FIELD CHANGE ORDER	Number: CI780-I006
--------------------	--------------------

Applicability: The L0118 Rev B\* module should be installed on all CI750, CI780, CIBCI, & HSCxx nodes used in VAXclusters of 6 (six) or more CI/HSC nodes connected to a common SC008 Star Coupler. L0118s should replace all L0100 Rev D\* link modules; L0100 Rev E\* can coexist with L0118s except in greater than 16 node environment.

FCO CI780-I006

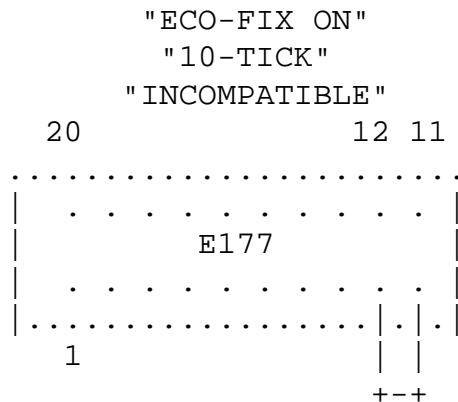
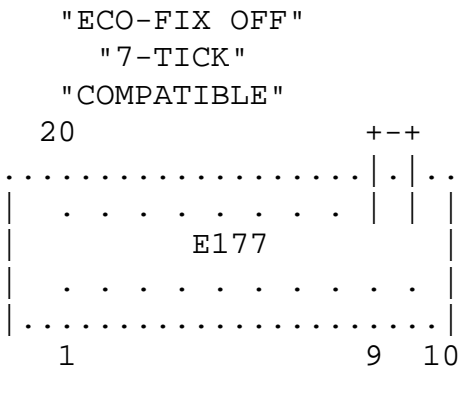
7. With L0118 (EQ-01454-05) on ESD Mat, configure and verify CI-LINK mode jumpers/switches for "7-TICK COMPATIBLE" MODE operation.

The L0118 also contains CLUSTER-SIZE switch and 4 (four) jumpers for MISC-FUNCTIONAL-MODES which should be checked. Install the new L0118 in the CIxxx option slot.

\*\*\*\*\*  
\*  
\* IMPORTANT - NOTE \*  
\* Copy old CI-NODE ADDRESS to new L0100/L0118. \*  
\* Ensure "7-TICK COMPATIBLE" mode is ENABLED/SET to avoid \*  
\* CI-PATH errors with L0100-D1 or other "7-TICK" CI/HSC \*  
\* nodes. The "10-TICK INCOMPATIBLE" mode cannot be used \*  
\* with L0100-D1 in cluster. Default L0100/L0118 manif. \*  
\* switch setting should be "7-TICK COMPATIBLE" mode. \*  
\*\*\*\*\*
